Re: Preliminary Draft Mound Basin Groundwater Sustainability Plan (July 2021)

The revised Draft GSP should be re-circulated to give NMFS, and other interested parties, an opportunity to review the revisions before the Draft GSP is finalized.

Figure G-12. Zone Budget Results for Selected Zones and the Stream Package.

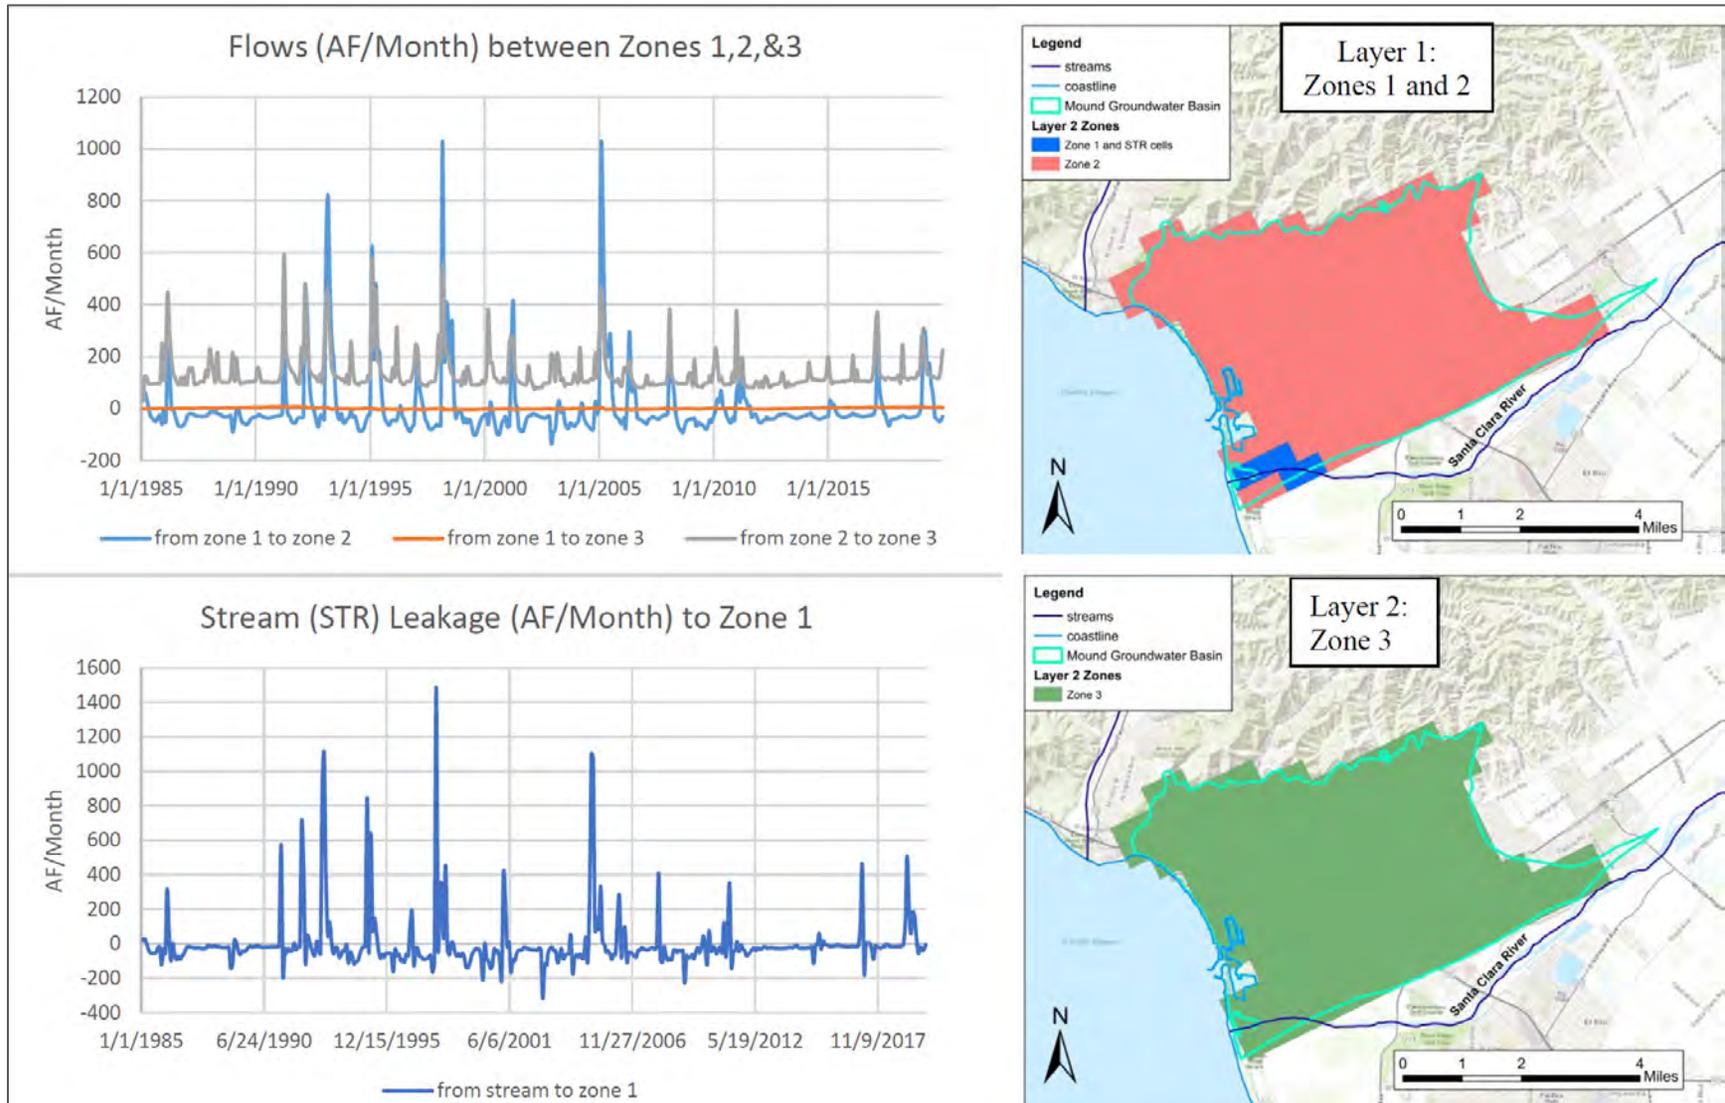
A zone budget analysis for the baseline historical numerical model utilized MODFLOW's zone budget tool to focus on the modeled flows between the Santa Clara River and the upper layers of the model. Three zones were delineated (Figure G-12):

Stream leakage flows from the Santa Clara River STR cells to zone 1 were also included in the analysis, computed from the STR boundary condition package from the numerical model. Observing the top chart in Figure G-12, during most of the simulated historical period lateral flows between zones 1 and 2 are negative (flow from zone 2 to zone 1) and are generally less than 100 AF/month. During high-stage, short-term storm events, flows are positive (flow from zone 1 to zone 2), with maximum rates for two events at approximately 1,000 AF/month. Overall, the net exchange (average flow) is essentially zero (5 AF/month). The upper graph also shows that flows from zone 1 to zone 3 (vertical exchange between the groundwater cells coincident with the Santa Clara STR boundary and layer 2) are negligible. Flows from zone 2 to zone 3 are notable and are always positive (from zone 2 to zone 3; downward from layer 1 to layer 2). These downward flows are usually greater in magnitude than the lateral flows between zones 1 and 2 except during a few peak events but are overall generally small (average 136 AF/month) and unevenly distributed across the 11,000-acre extent of the layer, with the highest rates in the central and eastern portions of the model, away from the Santa Clara River. For context, the overall average rate of inflows/outflows for the combined historical and current surface water budget is ~13,000 AF/month (~160,000 AF/yr; see GSP sections 3.3.1/3.3.2, Table 3.3-02).

The bottom chart on Figure G-12 is similar to the top chart flow between zone 1 and zone 2, and similarly indicates that during most of the historical time period flow is from zone 1 to the STR boundary cells, feeding it at low volumes. During peak events, the direction reverses and the stream is providing larger volumes to the cells directly beneath. In addition, the net exchange is zero.
